STATEMENT OF RESPONSE TO AN BORD PLEANÁLA'S CONSULTATION OPINION

IN RESPECT OF A
PROPOSED RESIDENTIAL DEVELOPMENT
AT ACADEMY STREET NAVAN, CO. MEATH
NOVEMBER 2019

Client:	Coindale Ltd.
Project Title:	Navan Belmont SHD
Document Title:	Statement of Response to An Bord Pleanála’s Consultation Opinion
Document No:	17160SRABP

Figure 3.5 – Typical Perimeter House Drainage and SuDS Details

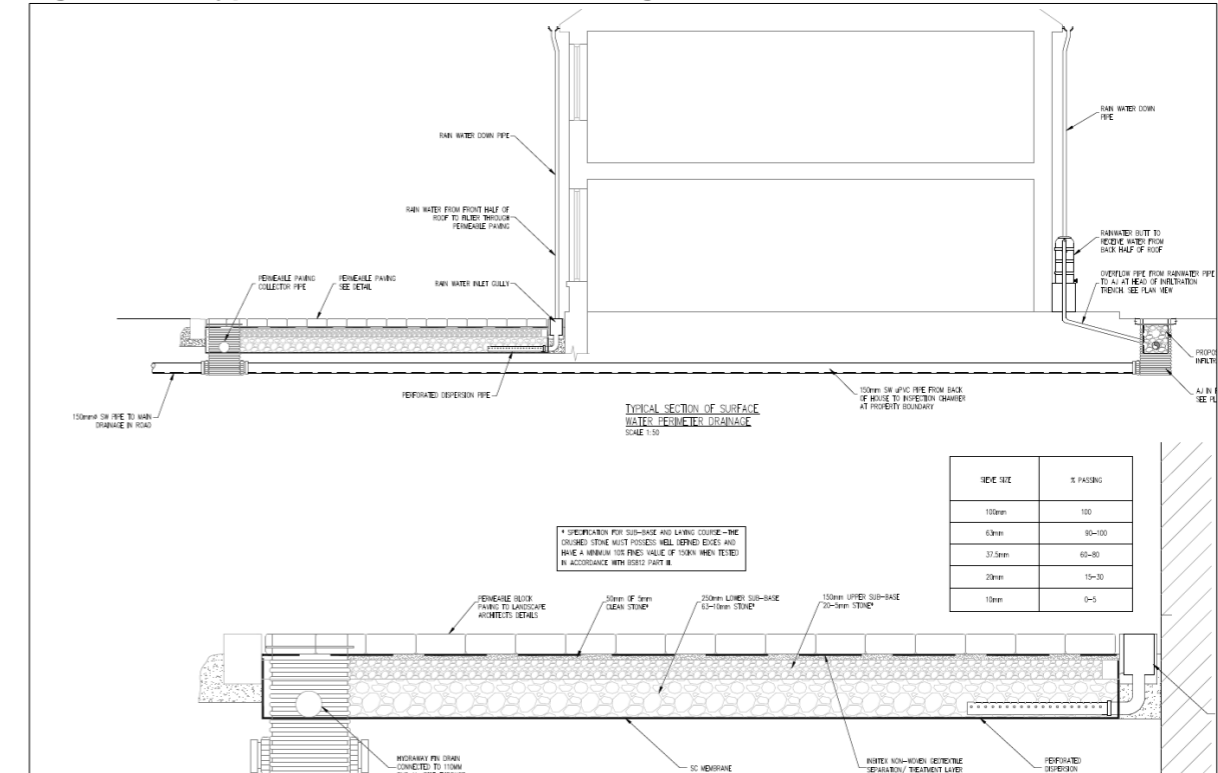
- *Detailed of proposed earthworks to address level differences on site, including detail of proposed cut and fill works and resultant gradient / retaining features.*
- *Design of the proposed surface water management system including attenuation features and cross sections of all SuDS features proposed on site in the context of surface water management on the site.*
- *Details of all materials proposed for buildings, open spaces, paved areas, boundary and retaining walls.*

16 Typical Perimeter House Drainage and SuDS Details are shown on CS drawing no. D061-069:

Figure 3.12 – Phasing

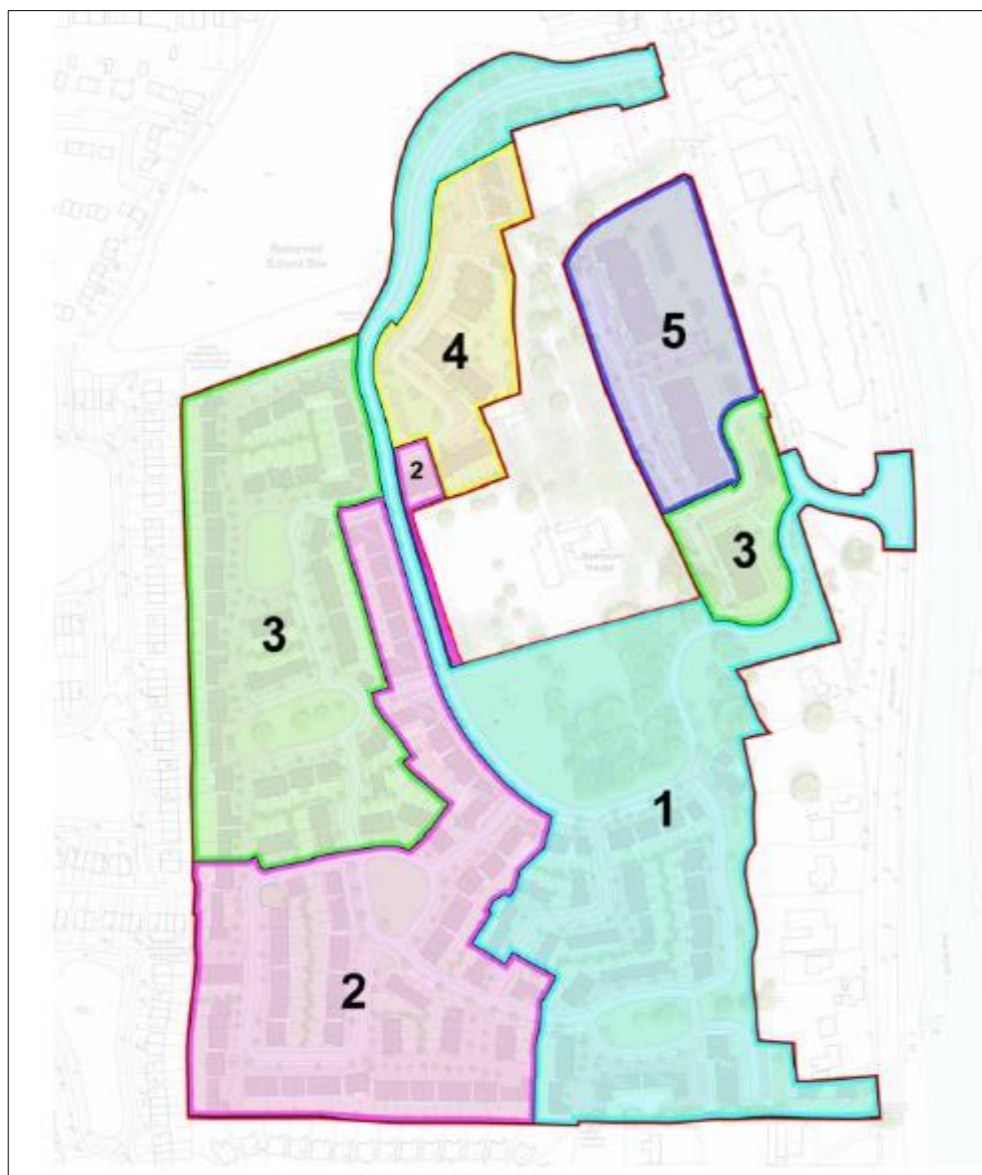
- *A detailed phasing plan for the proposed development should be provided.*
- *A site layout plan clearly indicating what areas are to be taken in charge by the Local Authority.*

49 In response to this item we refer the Board to the enclosed drawing no. 1828 P110, prepared by CCK Architects which shows the overall phasing of the proposed development. The indicative phasing is outlined below.

50 The expected construction staging provides for 5 phases. While the pace and timing of this phasing is highly dependent on unpredictable market conditions, the overall site design and phasing strategy takes account of the infrastructure and open space provisions associated with each phase.
